**ITEM #1 - PRELIMINARY PLAT
Diamond View Estates 2024**

KPB File No.	2024-040
Plat Committee Meeting:	May 28, 2024
Applicant / Owner:	Jerome Sookraj of Homer, Alaska
Surveyor:	Stephen C. Smith – Geovera, LLC
General Location:	Diamond Ridge Road, Homer Area

STAFF REPORT

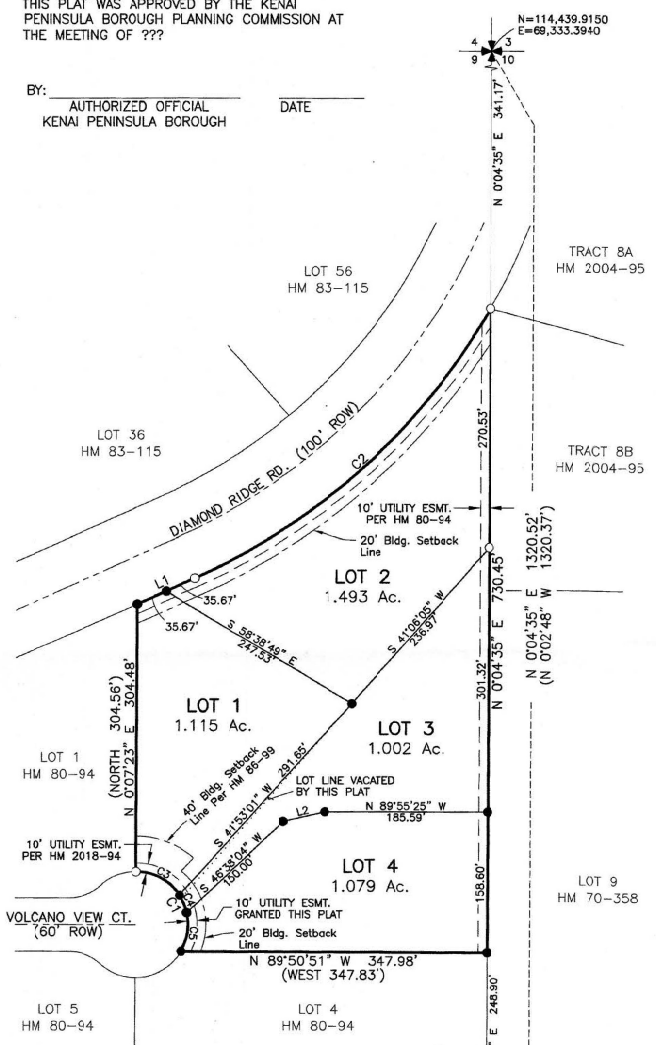
Volcano View Ct. will remain unaffected by this plat action except to make the cul-de-sac. RSA review shows concern that this is a driveway dense cul-de-sac and that an access permit for Lot 2 to Diamond Ridge Rd will be needed.

Block length is not compliant along Diamond Ridge Rd. This plat is unable to give a dedication to give relief to block length. Staff recommends; the Plat Committee concur an exception is not needed due to the plat not being in a position to give a dedication.

River Center review indicated the plat to be in a FEMA FIRM Zone X and recommends to include a plat note containing the standard flood hazard note in KPB 20.30.280.D and include the Map Panel with the note. Depiction in the drawing is not suggested.

The 10' utility easement granted per HM 2018-49 to be labeled on plat along border with Diamond Ridge Rd. The 10' utility easement identified along Volcano View Ct. to be labeled correctly as HM 2018-49 on Lot 1 and per this plat on Lots 3 & 4. Draw and label the 10' x 10' HEA Easement per HM 86-99 on the north line near Diamond Ridge Rd also.

HEA	Provide a label for the 10' utility easement granted per HM 2018-49, Correct the reference to plat number 2018-49.
ENSTAR	No comment
ACS	No objections
GCI	Approved as shown

Add the KPB file 2024-040 to the title block

There is an existing trail shown on the asbuilt included in the certificate to plat and visible on the aerial photo, this should be added to the drawing and labeled.

- J. Block and lot numbering per KPB 20.60.140, approximate dimensions and total numbers of proposed lots;
Staff recommendation: *Lot 3 is within a previous recent Lot 3. Lot 2 similar issue. Consider 3A & 2C possibly*

Diamond Ridge property access permitted through AK DOT. Application for driveway access from Lot 2 to state ROW will need to be approved.

Add to the drawing the 10' x 10' utility on the north line against Diamond Ridge Drive as created by HM86-99

Add map panel info

10' utility easement granted per HM 2018-49 to be labeled on plat along border with Diamond Ridge Rd.

10' utility easement identified along Volcano View Ct. to be labeled correctly as HM 2018-49 on Lot 1 and specify that on Lots 3 & 4 for this plat.

- "No access to state-maintained rights-of-way permitted unless approved by the State of Alaska Department of Transportation."
- Add a plat note referencing plat note #4 HM 86-99 to the plat
- *The borough will not enforce private covenants, easements, or deed restrictions per KPB 20.60.170.*

Add the date of May 28, 2024 to the Plat Approval
